**FINAL EXPRESS TERMS
FOR
PROPOSED BUILDING STANDARDS
OF THE
CALIFORNIA DEPARTMENT OF PUBLIC HEALTH**

**REGARDING PROPOSED CHANGES TO
THE CALIFORNIA BUILDING STANDARDS, ADMINISTRATIVE CODE
CALIFORNIA CODE OF REGULATIONS, TITLE 24, PART 2, Chapter 31B
PUBLIC POOLS**

EXPRESS TERMS

FIGURE 31B-1
 DEPTHS AND CLEARANCES FOR POOLS WITH DIVING BOARDS
 GREATER THAN 30 INCHES (762 mm) ABOVE THE WATER LINE

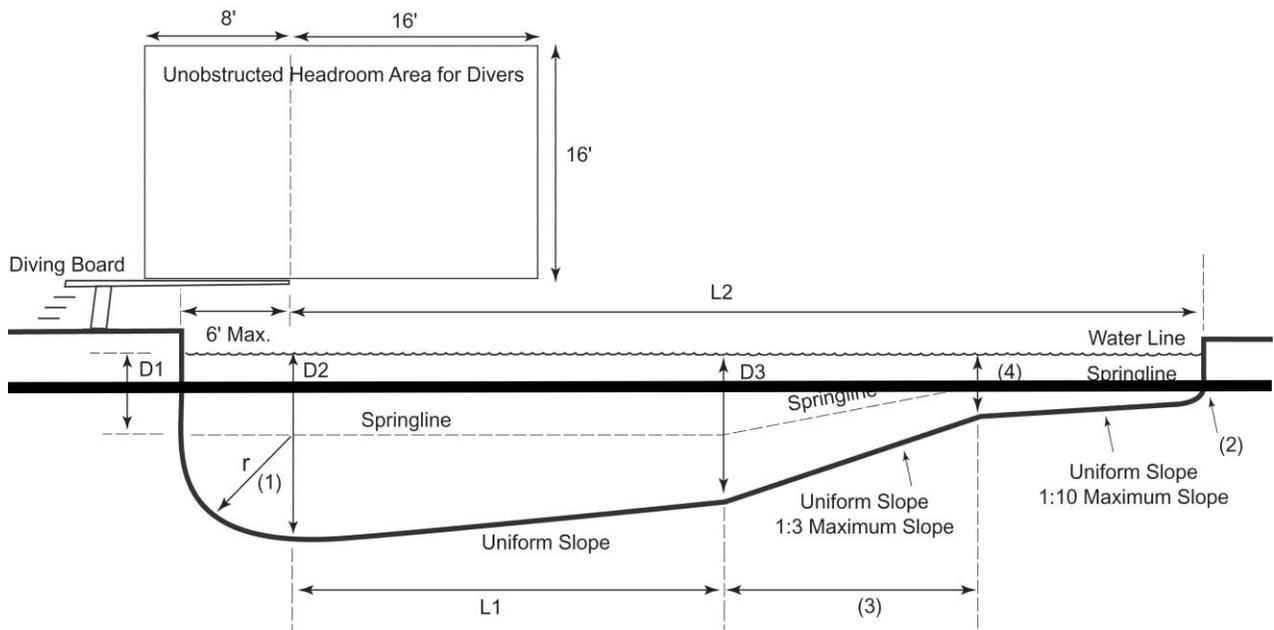
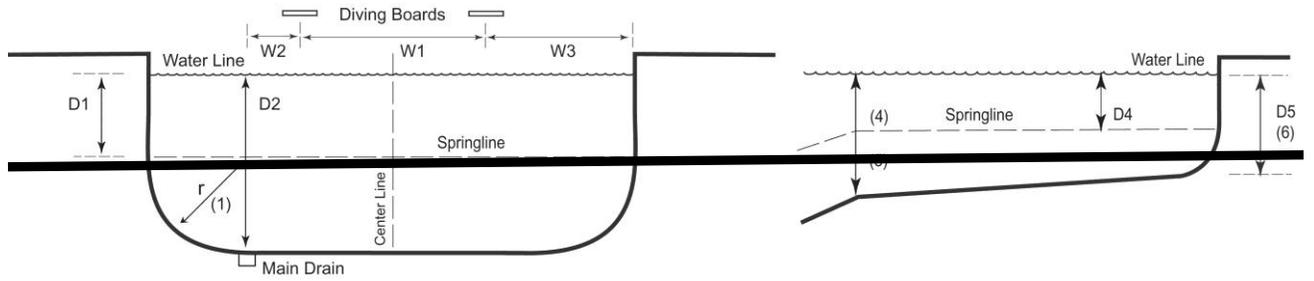
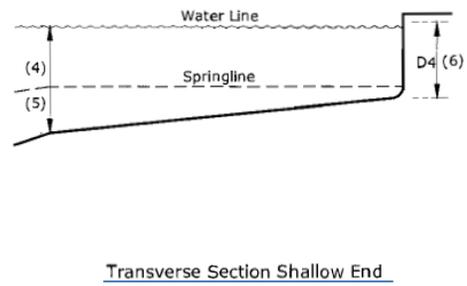
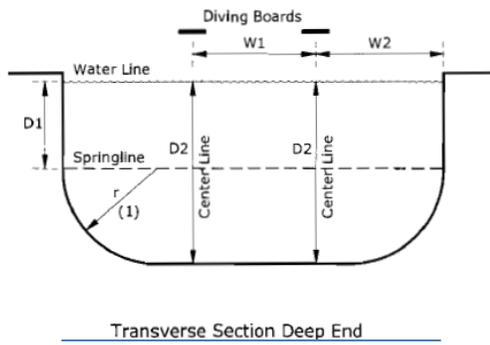
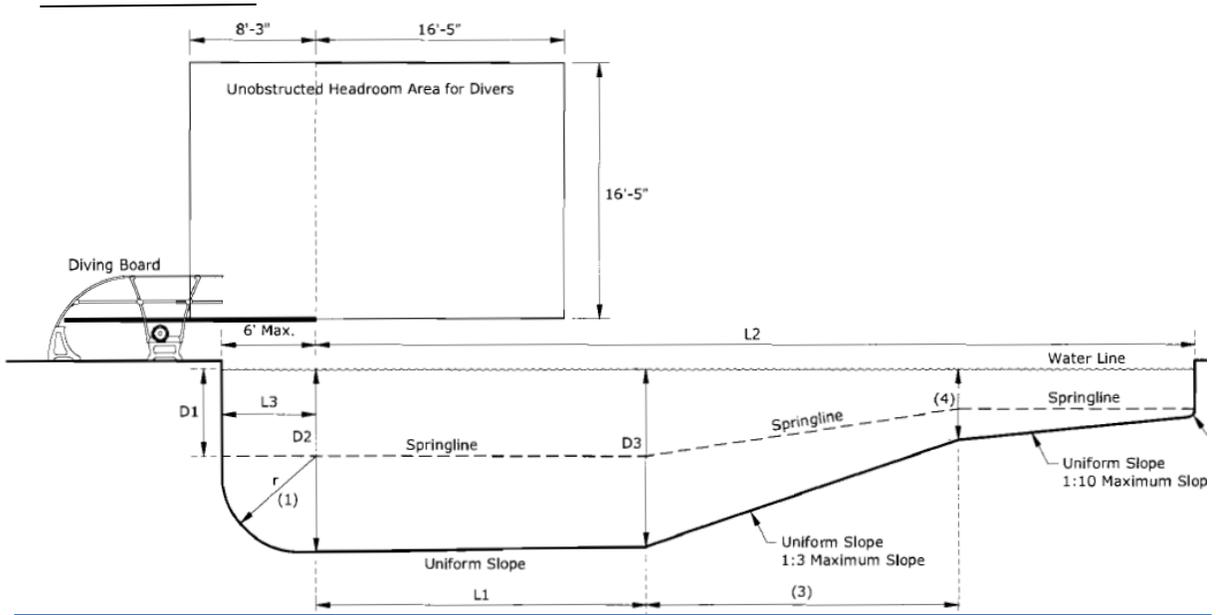
30) Amend Figure 31 B – 1 and Table 31 B -1 and Notes for Figure 31B-1 and Table 31B-1

1. Maximum radius shall equal D2 minus D1 dimensions.
2. Radius at the shallow end shall not be ~~not less than 6 inches~~ nor more than 12 inches.
3. The length of a section is based on the maximum slope and other maximum and minimum dimensions.
4. Where there is a break in slope, the break shall be located at a water depth equal to 4'6".
5. The springline depth at (4) shall not be ~~less than 2'6"~~ nor more than 4'0".
6. The maximum water depth shall be 3'6".
7. ~~The main drain shall be located to provide complete drainage of the pool.~~ Each pool shall be provided with a main drain submerged suction outlet typically located at the bottom of the pool that conducts water to a recirculating pump.

FIGURE 31B-2
DEPTHS AND CLEARANCES FOR POOLS WITH DIVING BOARDS
30 INCHES (762 mm) OR LESS ABOVE THE WATER LINE

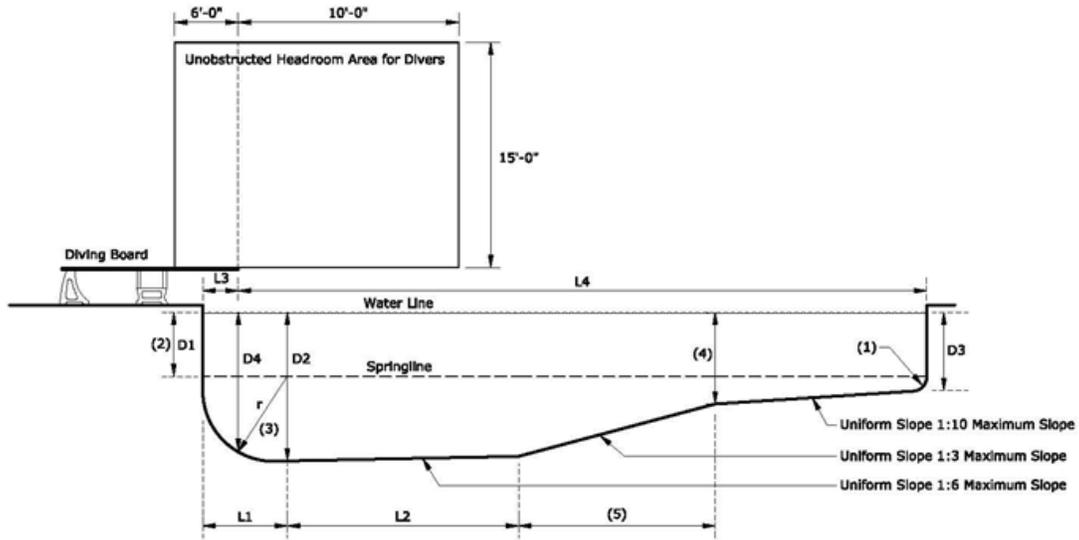
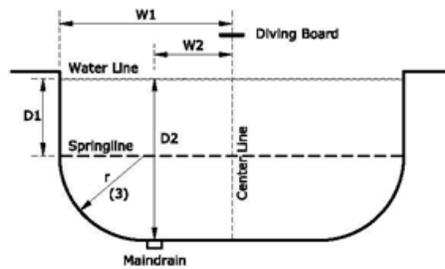
31) Amend Notes for Figure 31B-2 and Table 31B-2

1. Radius at the shallow end shall be a ~~minimum of 0'6"~~ and a maximum of 1'0".
2. Springline D1 shall extend to the break in slope between the shallow area and the deep area.
3. Maximum radius shall equal D2 minus D1 dimensions.
4. Where there is a break in slope, the ~~break in slope~~ shall be located at a water depth equal to 4'6".
5. Length of section is based on maximum slope and other maximum or minimum dimensions.
6. The main drain shall be located to provide complete drainage of the pool. Each pool shall be provided with a main drain submerged suction outlet typically located at the bottom of the pool that conducts water to a recirculating pump.

FIGURE 31B-3 DEPTHS AND CLEARANCES FOR POOLS WITHOUT DIVING BOARDS

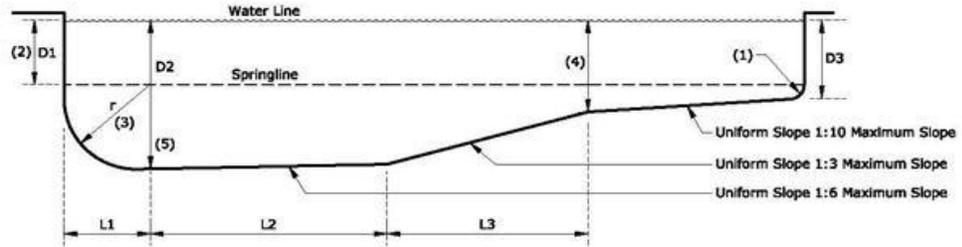
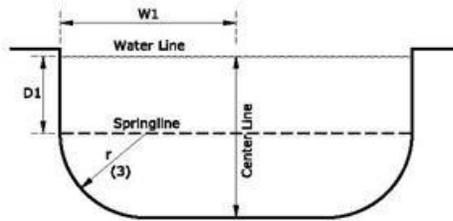
32) Amend Notes for Figure 31B-3 and Tables 31B-3a and 31B-3b

1. Radius at the shallow end shall be a ~~minimum of 0'-6"~~ and a maximum of 1'-0".
2. Springline D1 shall extend to the break in slope between the shallow area and deep area.
3. Maximum radius shall equal D2 minus D1 dimensions.
4. Where there is a break in slope, the break ~~in slope~~ shall be located at a water depth equal to 4'-6".
5. ~~The main drain shall be located to provide complete drainage of the pool.~~ Each pool shall be provided with a main drain submerged suction outlet typically located at the bottom of the pool that conducts water to a recirculating pump.
